SUNDRY NOTICES AND REPORTS ON WELLS

8. Well Name and No.
Drickey Queen Sand Unit #38

Proposed P&A Report
Acacia Operating Company, LLC
Drickey Queen Sand Unit #38
30-005-01037

Drickey Queen Sand Unit 38
30-005-01037
ConocoPhillips
December 2, 2025
Conditions of Approval

Proposed
Wellbore Diagram

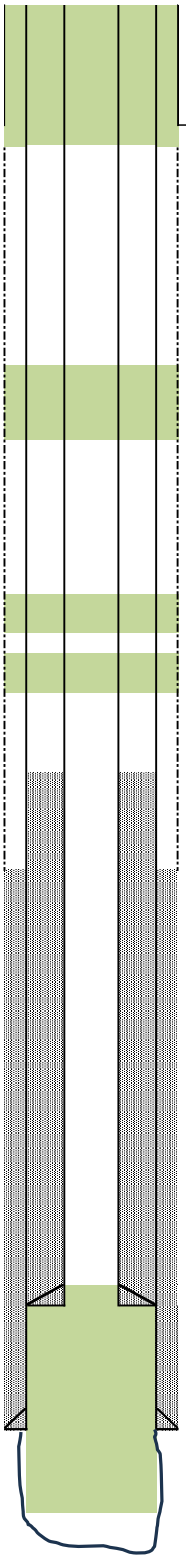
1. **Operator shall place a balanced Class C cement plug from 2,830-2,700' to seal the top of the liner. WOC and TAG.**

2. **Operator shall perf at 2,172' and squeeze Class C plug from 2,172' to 2,040' to seal the top of the Yates. WOC and TAG.**

3. **Operator shall perf at 2,000' and squeeze class C cement to 1,879' to seal the base of Salt. WOC and TAG.**

4. **Operator perf at 1380' and squeeze Class C Cement to 1,157' to seal the top of Salt and Rustler.**

5. **Operator shall perf at 350' and squeeze cement class C cement to surface.**

6. **Dry hole marker must be below ground.**

Created By	Condition	Condition Date
loren.diede	Notify the OCD inspection supervisor via email 24 hours prior to beginning Plug & Abandon (P&A) operations.	12/3/2025
loren.diede	NMOCD concurs with the BLM-picked formation tops: Rustler = 1207', T Salt = 1330', B Salt = 1950', Yates = 2122' and Queen = 2855'. Please use these formation tops and the plugs as outlined in the BLM COAs.	12/4/2025
loren.diede	NMOCD has determined that this well is not within the LPCH restricted area and an above ground P&A marker is required.	12/4/2025
loren.diede	Submit CBL tif file to NMOCD for upload into the Well Log File.	12/4/2025
loren.diede	Submit photo and GPS coordinates of the P&A marker with the C-103P subsequent report. The API# on the P&A marker must be clearly legible.	12/4/2025
